## Supplementary Submission to IPC on Narrabri Gas Project

Supplementary Submission to be included with the original submission - by Tony Pickard

Figure 7 | Typical Coal Seam Gas Well

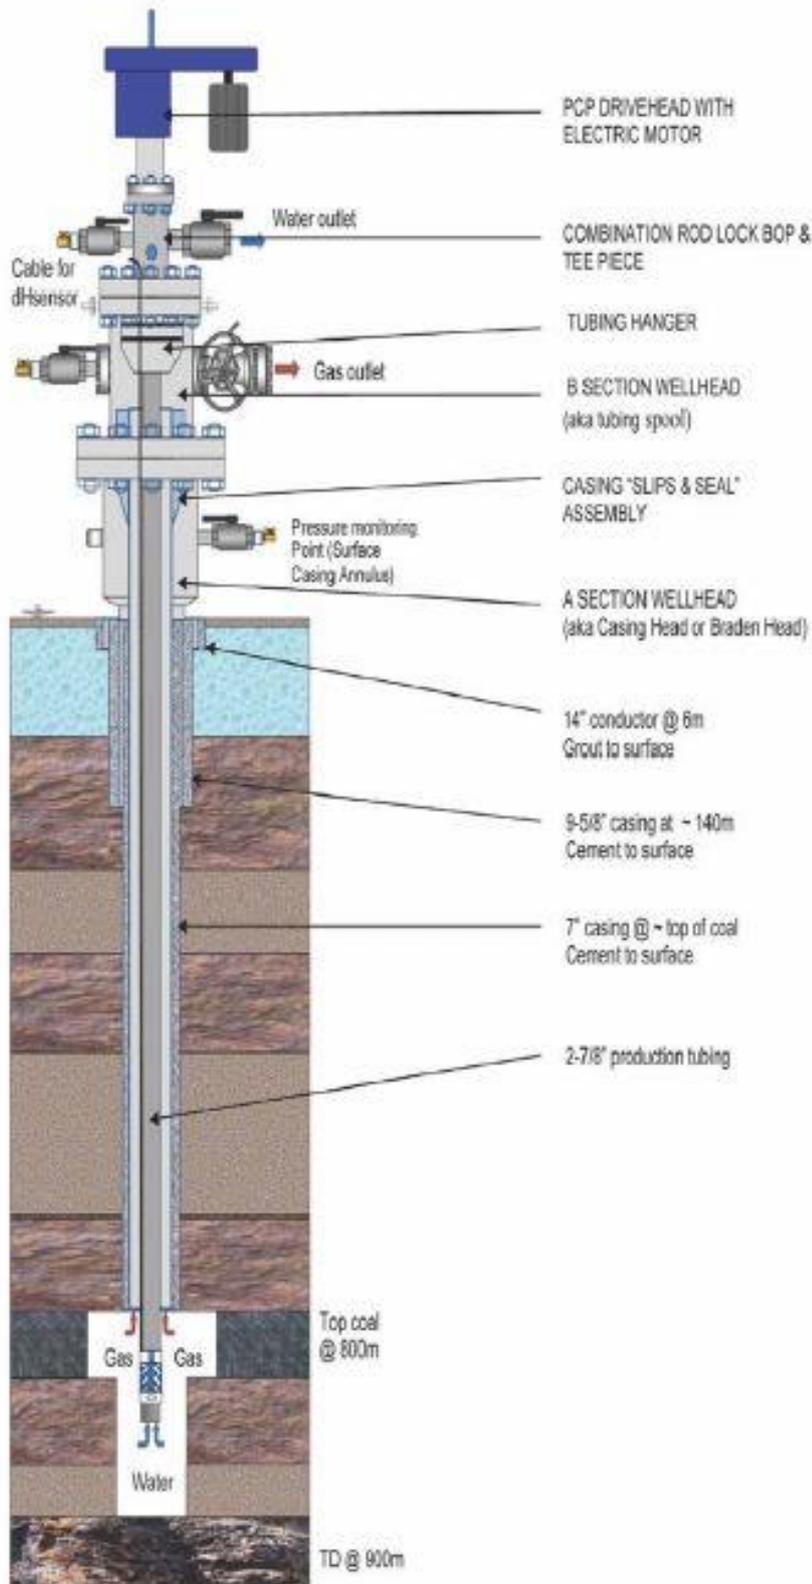
Please note that all of the pictorial representations show a perfect alignment/spacing of the gas well inner casings to the outer casings with perfect cementing in between yet the reality is very different as has been demonstrated.

I know that according to the Well Completion Reports that spacers are supposed to be fitted and installed when a casing is first fitted and prior to cementing, but who checks to see if all the spacers are still in position and that the casing is indeed central inside the hole into which it has been put prior to cementing? My guess is, that bit of important

confirmation is not done, mainly because if a spacer was found to be missing or extra spacers required due to the curvature of the drilling as it approaches the target seam, it would cost too much to firstly run a gamma ray or similar Data log check and if a problem were found, to pull the casing string up and correct the problem.

The IPC should look into why the facts as displayed are contrary to those put about in the glossies and in the written descriptions contained therein. There should be such a thing as "Truth in the Industry and Industry Publications" applied.

Maybe the IPC should make a pre cementing Data logging check of the casing position relative to the centre of a hole a condition in the Development Consent. To do otherwise is to sanction a very great probability of early well casing failure due to corrosion or bacterial attack and to also sanction shoddy workmanship.

**Figure 6.2.** Potential pathways for leakage along an abandoned well, including flow along the material interfaces (a, b, f) and through well cements and casings (c, d, e) (After Nordbotten et al. (2005))

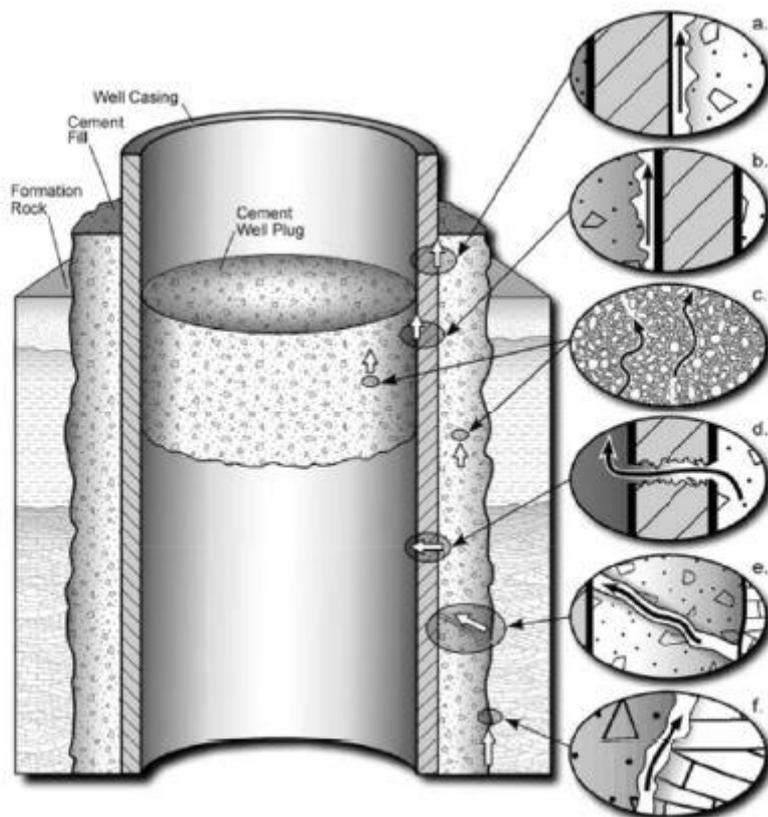
This image can also be used to show the potential external pathways for bacteria in the groundwater to attack the cement and the inner steel of the well casing (see the Microbial Corrosion Att 4.7 Sub 13 Microbial Corrosion).

This image also supports the concerns raised by many members of the questioning community including myself and now again raised in this chapter with regard to the P&A done on Bohena 2 and possibly other wells that have been P&Aed and with the lack of proper long term monitoring of either the groundwater or the well cement or casing condition (see email from WEP to DPI&I in the Assessment Report) that has been raised in the past and rejected as being impracticable by Santos, the Regulator the EPA and the Department of Planning.

The other disturbing fact as it stands today; is how is the Gas Company or that NSW Government Department going to repair any casing or cement damage, if it is ever found, once a gas well is P&A?
